Green Smart Shirts Ltd (Extension)

Tapirbari, Mawna, Sreepur, Gazipur
(24.2373838, 90.4342180)
18 September 2023

Observations

Bracings and strut layout

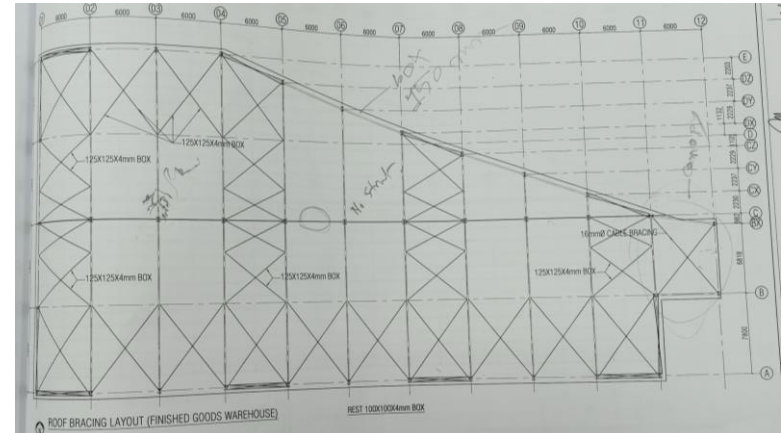
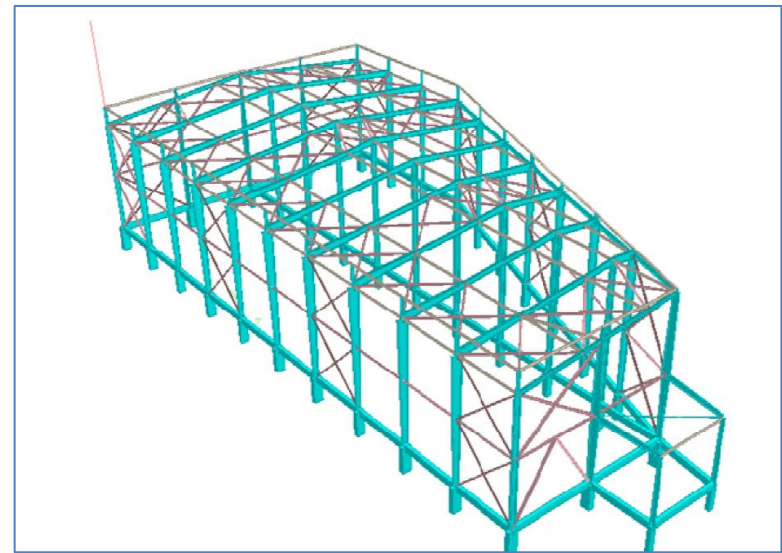
Incomplete lateral stability system

No compression strut was found along the ridge lines of the long direction. So lateral stability in the long direction is incomplete. The building engineer is required to check the stability system of the existing structure.

Inclined steel column

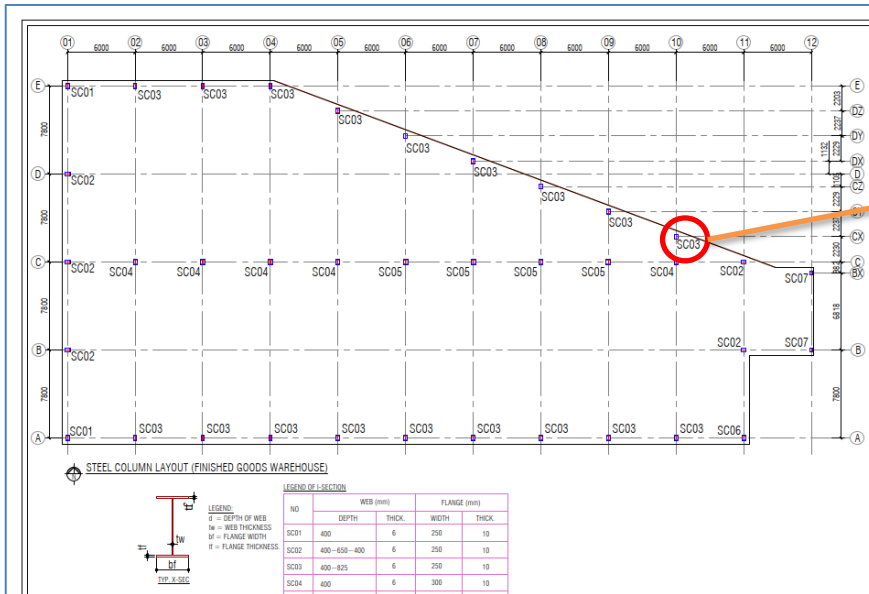
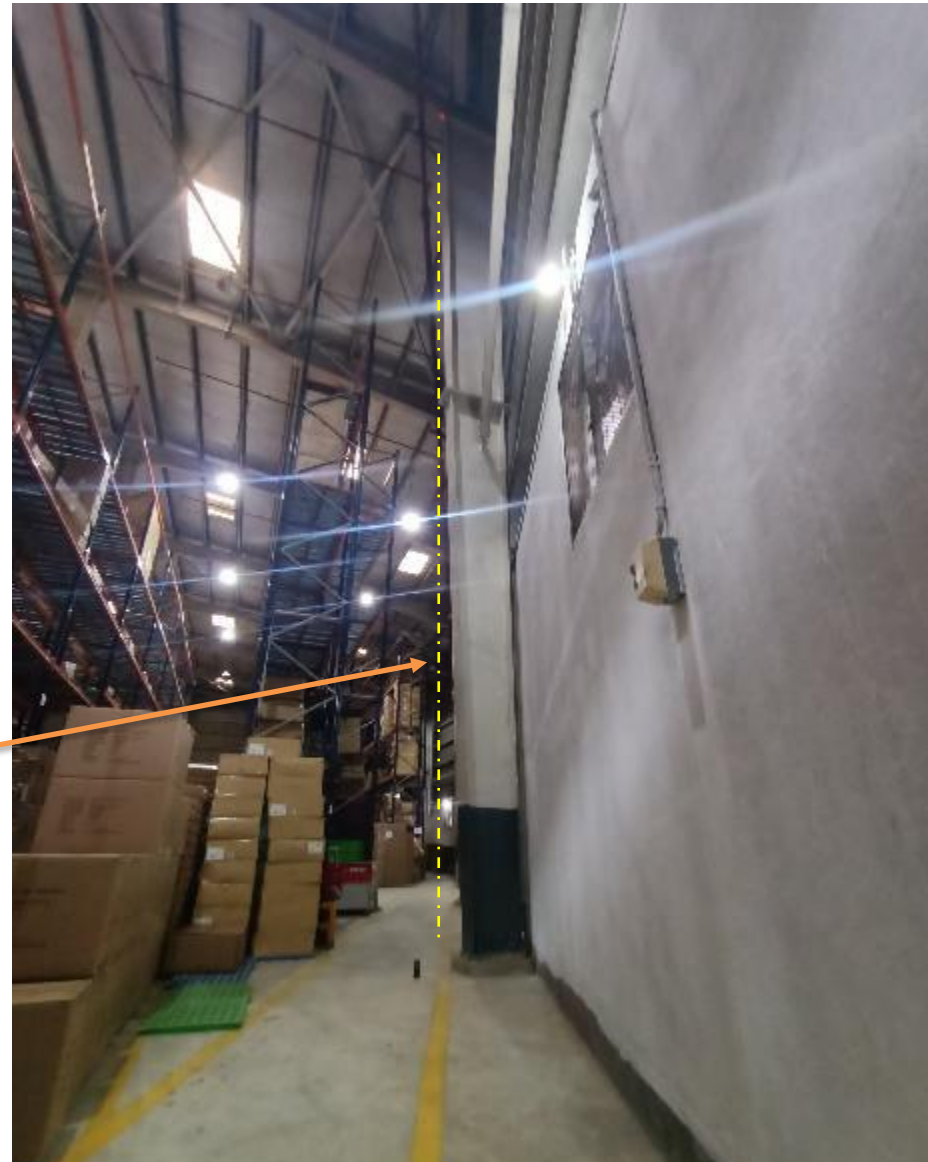
An inclined steel web column was found on the North side of the shed. The stability of the distorted columns and related elements need to be checked.

lateral stability system required review

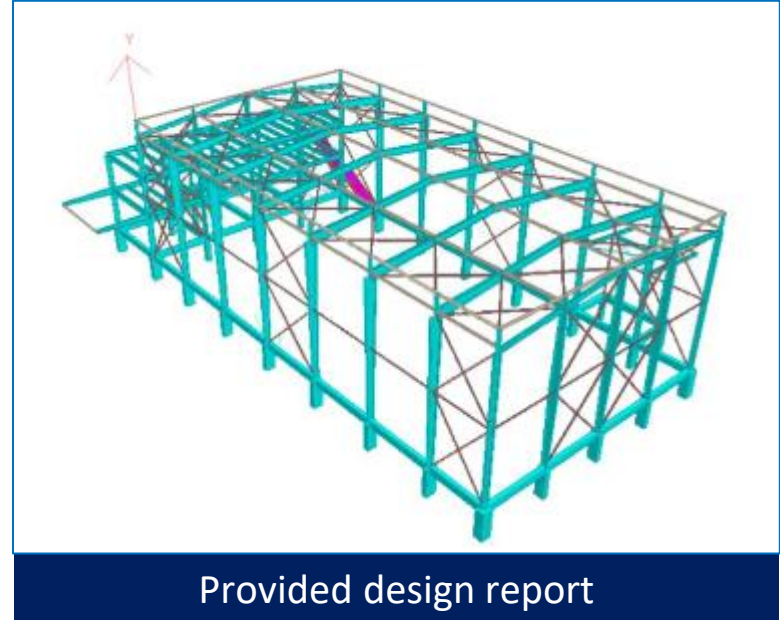
No compression strut was found along the ridge of the long direction. So lateral stability in the long direction is incomplete. The building engineer is required to check the stability system of the existing structure.

Inverted V bracing

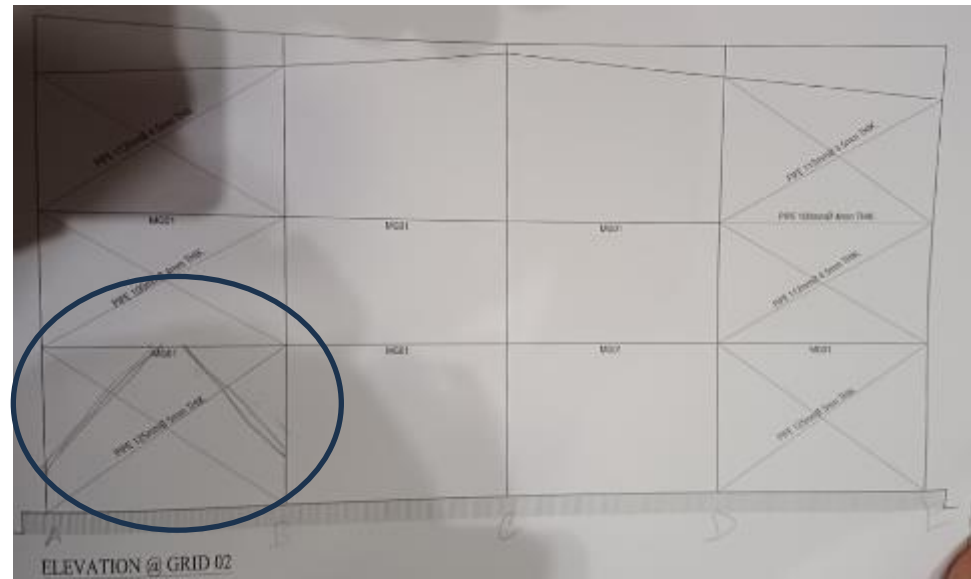
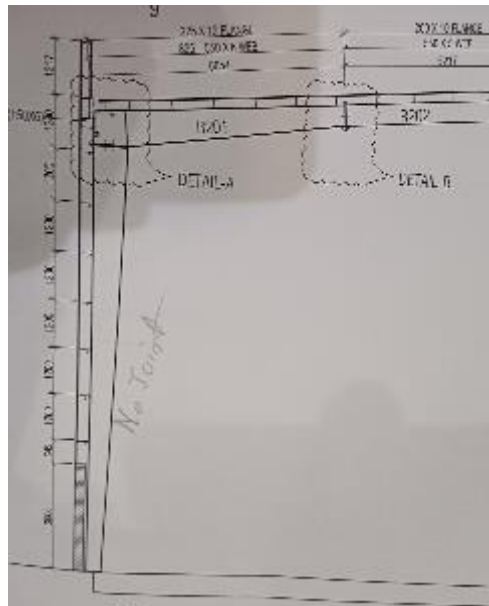
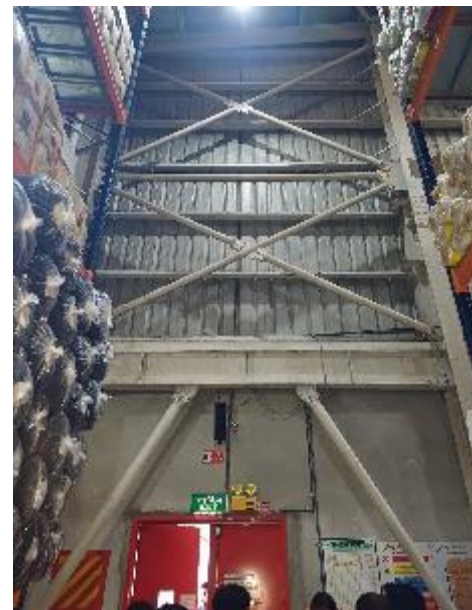
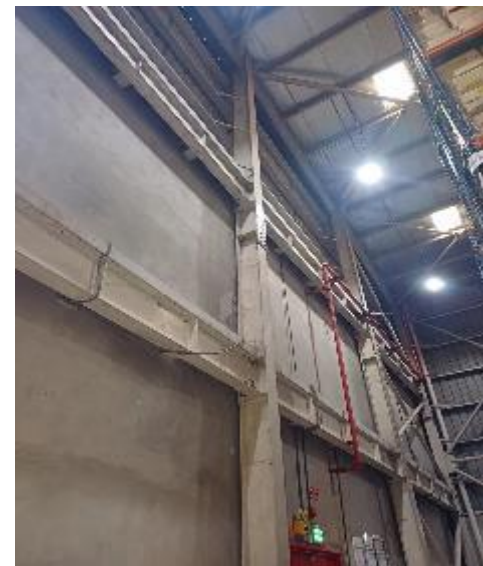
Inverted V bracing was found instead of cross bracing at grid 2. Column splice detail is not found in the provided as-built drawings. Moreover, all connection details are not found in the drawings.

Building engineer is required to revise the as-built drawing showing connection details with complete information.

No load transfer media along long direction

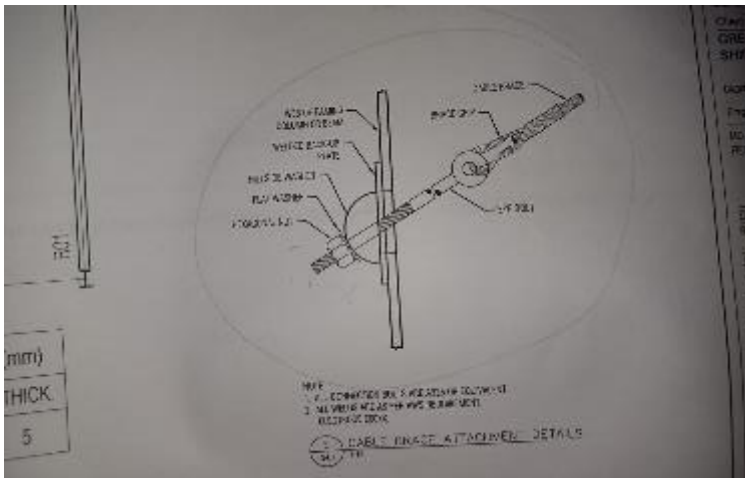
Load transfer media is not provided along long direction for this shed. Therefore, lateral stability system of the shed is apparently incomplete. Building engineer is required to check the lateral stability of the structure.
